Planning Rationale + Design Brief

3075 PALLADIUM DR., OTTAWA

Site Plan Control Application

December 20th, 2024

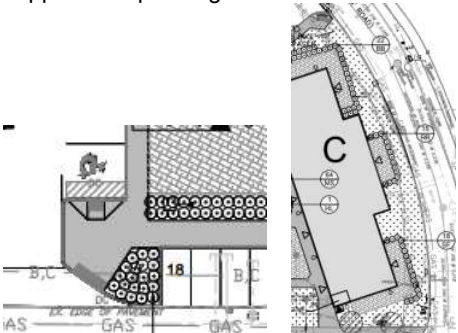
Landscape Plan	
69	Please include all required items listed within the Landscape Plan Terms of Reference on the Landscape Plan. The soil volume calculations must be demonstrated on the plans to ensure that all greenspace with sufficient soil includes a tree and that all trees are provided with sufficient soil volume.	Please refer to updated Landscape Plan.
70	Confirm that the soil volume provided around the existing trees is not only sufficient for the protection through construction, but also to support their long-term growth and survival. E.g., trees 17 & 18 	Tree 17 is removed and replace with new trees. Please refer to updated Landscape Plan.
71	Please label the existing trees on the Landscape Plan as per the TCR for ease of reference.	Please refer to updated Landscape Plan.

72	<p>The projected canopy cover for the site is 11%. It appears that there is space to plant additional trees east of building C, to improve both the canopy cover and streetscape in this area. In other areas, consider expanding some of the parking lot islands/boulevards or reducing the sidewalk coverage or # of parking spaces to support tree planting.</p> 	Addressed. Please refer to updated Landscape Plan.
73	As per the direction of the Official Plan, Section 4.8.2 Policy 3, it is strongly recommended to provide additional space within the site to plant trees to increase the canopy cover projection and to decrease the urban heat island effect from the large amount of parking.	Additional trees are provided. Please refer to updated Landscape Plan.
74	Please consider replacing proposed vegetation with invasive tendencies (e.g. Euonymus alatus) with native or non-invasive species.	Addressed. Please refer to updated Landscape Plan.
